INSTRUCTION TO SERVICE

ITS: 60986		March 25, 2024
SECTION:	260-BATTERY COMPARTMENT	
WRITTEN BY:	Ilan Kizner	
SUBJECT:	Rework - Route LV harness away from auxiliary heater Fuses	
SUMMARY:	this ITS provides instructions on how to relocate the connectors inside the Rear HV Electrical Box to avoid any potential interfere with the fuses. the following instructions apply for assembly's: 939278, 939714, 940965, 943709, 981577, 895068, 897426, 913723 and 929873

Figure 1-location of XBBEP16 and AUX HTR connectors

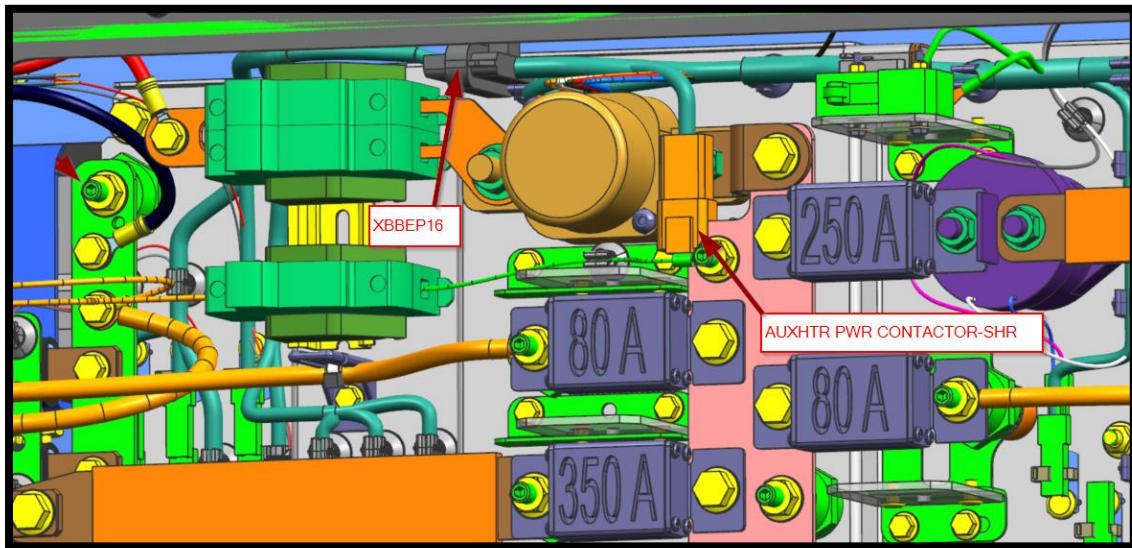
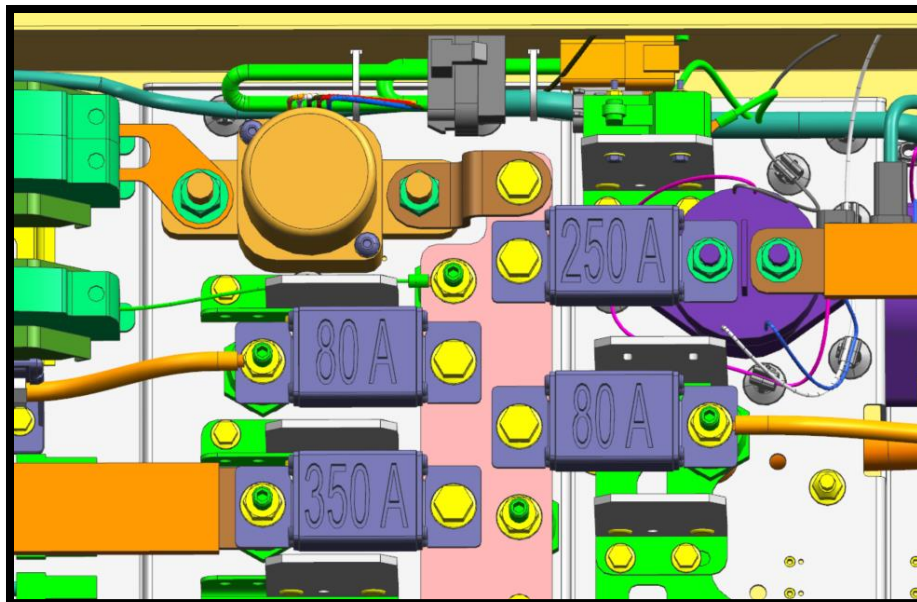
- 2.1. Locate the Eng DC Link Dist Box, located at the rear engine compartment.
- 2.2. Remove the Distribution box cover.
- 2.3. Locate connector AUXHTR PWR CONTACTOR-SHR. Shown in figure 1. Pull the connector back toward the limit switch as per figure 2 and secure to the harness using Tyrap- 5962614.
- 2.4. Locate connector XBBEP16, Shown in figure 1. Pull the connector back away from the fuses toward the limit switch as per figure 2 and secure to the harness using Tyrap- 5962614.

Figure 2-Location of connectors after rework
